**DOE/EIS-0108
Volume 3 of 3**

**FINAL
ENVIRONMENTAL IMPACT STATEMENT**

**L-Reactor Operation
Savannah River Plant**

COMMENTS AND DOE RESPONSES ON DRAFT ENVIRONMENTAL IMPACT STATEMENT L-REACTOR OPERATION

Figure 1. Equal Head Location Assuming 6-m Drawdown.

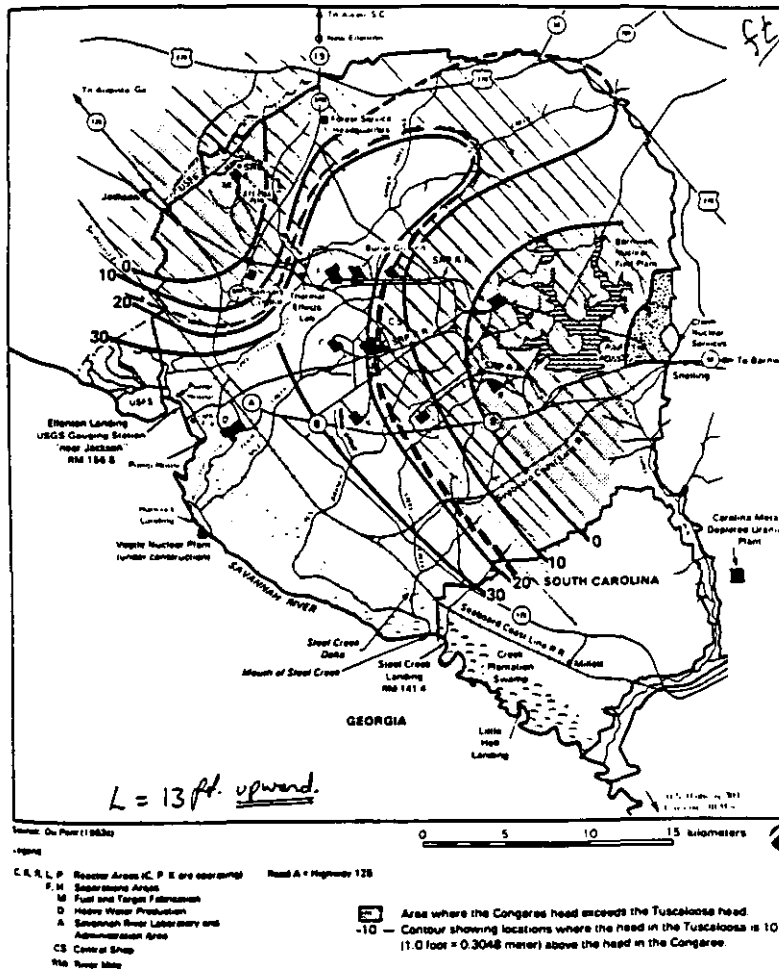
Comment number	Comments	Responses
	<p>This concern is further confounded by extrapolating the well water levels shown in Fig. 3-11 into the future. The water level (I assume stagnant) in well P7A has been declining at the average rate of 0.16 m/yr. and at this rate will reach the head levels in the Congaree (55.0 m) in 2012. A similar extrapolation for wells P5A, P54, and P3A shows the gradient reversal will occur in about 1990 for well P5A and that it already has occurred for the other two wells. I feel the key point which needs to be brought out in the EIS is that a closer look at these data reveals a problem which already exists is the area of the Par Pond and will more than likely increase in magnitude with time assuming the water withdrawal rates at SRP continue to remain about constant. The startup of the L-Reactor will have only a very small impact on this rate of change since the increased water for the L-Reactor is small.</p>	<p>Sections 3.4.2 and F.2 is how the characteristics of the hydro-stratigraphic units in the central portion of the SRP afford protection against the contamination of the Tuscaloosa aquifers. The clay layer at the base of the Congaree formation and the upper clay layer of the Eilenton formation are effective confining units and tend to protect lower ground-water sands throughout the SRP (see the response to comment AJ-1, Table F-1, and Section 5.1.1.4, which have been revised). Pollutants entering shallow groundwater will migrate to onsite streams. This is not the case in M-Area, as noted in Section 5.1.1.4, and in the response to AJ-1.</p>
